SB-GA8-2013-99

Service Bulletin

Inspection and modification of Strut Pick-up ribs – Rib no. 5 and Rib no. 6

Issue 3: Part 1 and 2 enhanced. Parts 3, 4 and 5 added.

Figure 40: Typical installation of Large and Small Doublers

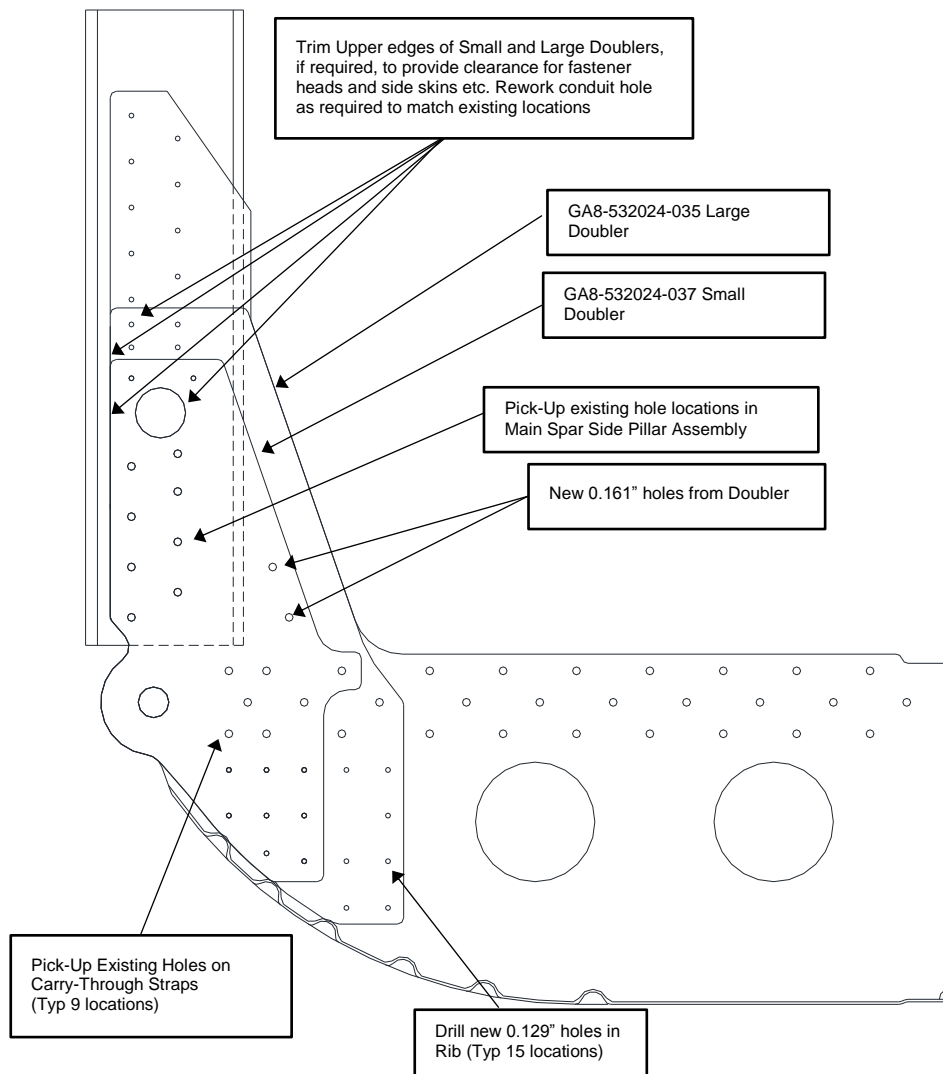
- 5) Match drill holes to the replacement Ribs #5 and #6 at existing locations in the Carry-Through Straps, Main Side Spar Pillar Assembly, Keel and Belly Skin (See Figure 40). De-burr all new holes.

- 12) Drill new holes using a #20 drill, to a diameter of 0.161", into the replacement Ribs #5 and #6 using the pilot hole locations of the Large Doublers which exist above the floor skin water-line (See Figure 40).

- 13) Drill 15 new holes, using a #30 drill, to a diameter of 0.129", through the lower web of the replacement Rib #5 and #6 using the pilot hole locations in the Large Doublers below the floor skin water-line (See Figure 40).

- 1) Position the replacement Rib and the Small and Large Doublers in place (See Figure 40). Place the Spacer, from Part 5-N, between the Carry-Through Straps so that the Wing Strut attachment bolt may pass through the Spacer.

- 3) Verify adequate clearance is provided from adjacent structure including: the Floor Attach Angle, Cabin Side-Wall Skins (See Figure 40). Ensure that the Large Doubler inboard vertical edge does not project beyond the Rib #5 and #6 inboard edge profile. If adequate clearance exists with Large and Small Doublers in position then proceed to Step (10) otherwise continue with Steps (4) through (9) as necessary.

- 4) Trim, if required, the outboard end of Floor Attach Angle to ensure clearance from the Large and Small Doublers (See Figure 40).
- 5) Trim, if required, the upper edges of the Large and Small Doublers to ensure adequate structural clearance from the Cabin Side-Wall Skins and to avoid fouling on any rivet heads (See Figure 40).

- 6) Trim, if required, the penetration holes in the Large and Small Doublers to provide clearance for the aileron cable conduit penetration (See Figure 40).

- 13) Install three MS20470AD5 rivets through the Floor Attach Angle, Rib #5 and #6, Carry-Through Straps and the Large and Small Doublers (rivet grip length to be verified on installation) (See Figure 40).

- 14) Install quantity of four MS20470AD5 rivets through the Large and Small Doublers, Rib #5 and #6 and the Carry-Through Straps (rivet grip length to be verified on installation) (See Figure 40).

- 15) Install quantity of four MS20470AD5 rivets through the Large and Small Doublers, Rib #5 and #6 and the Carry-Through Straps (rivet grip length to be verified on installation) (See Figure 40).

- 18) Install quantity of two MS20470AD5 rivets through the Large Doubler, Rib #5 and #6 and the Carry-Through Straps (rivet grip length to be verified on installation) (See Figure 40).

- 19) Install quantity of fifteen MS20470AD4 rivets through the lower web of Rib 5 and 6 and the Large and Small Doublers (rivet grip length to be verified on installation) (See Figure 40).

Figure 41: Inboard Fitting anchor-nut installation

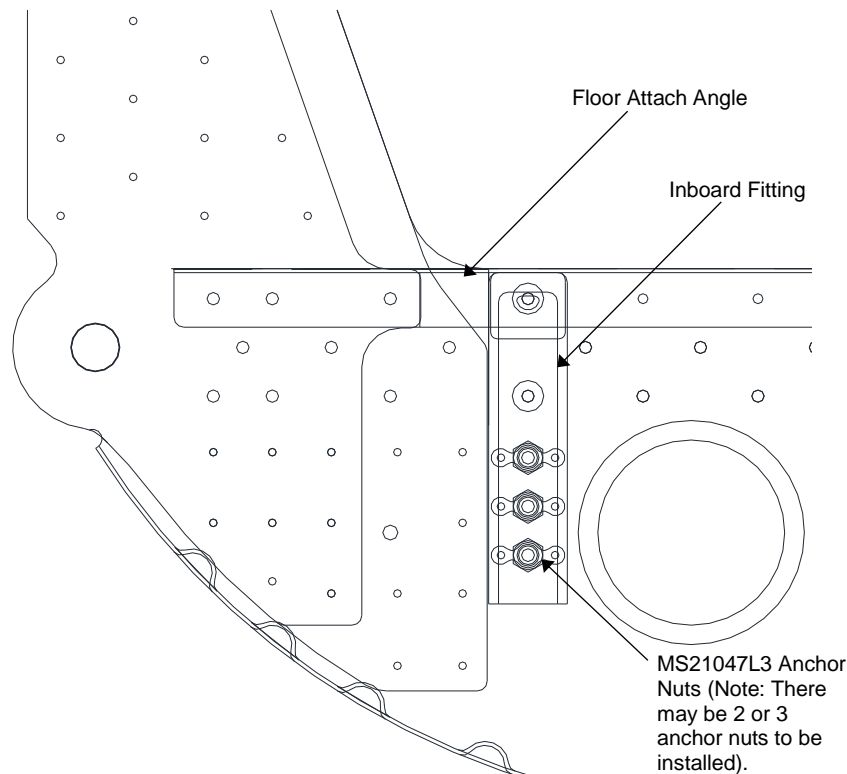
- 17) Pin the Floor Attach angle to Rib #6.
- 18) Place the Inboard Fitting removed in 5-N, below the Floor Attach Angle and against Rib#6. Temporarily install an existing seat rail mounting screw through the rear seat rail attachment hole and into the inboard fitting to fasten the inboard fitting up against the skin/trim angle. (See Figure 41).

- 22) Place an MS21047L3 Anchor nut over each of the 0.191" holes, and using it as a template, back-drill the two rivet holes into Rib #6 using a #40 drill to a diameter of 0.098" (See Figure 41).

- 23) Countersink these 0.098" holes on the Inboard Fitting side of the Rib, to a depth to suit the head of an MS20426AD3 rivet.
- 24) Install the MS21047L3 anchor nuts to Rib#5 using MS20426AD3 rivets (assess rivet length on installation) (See Figure 41).
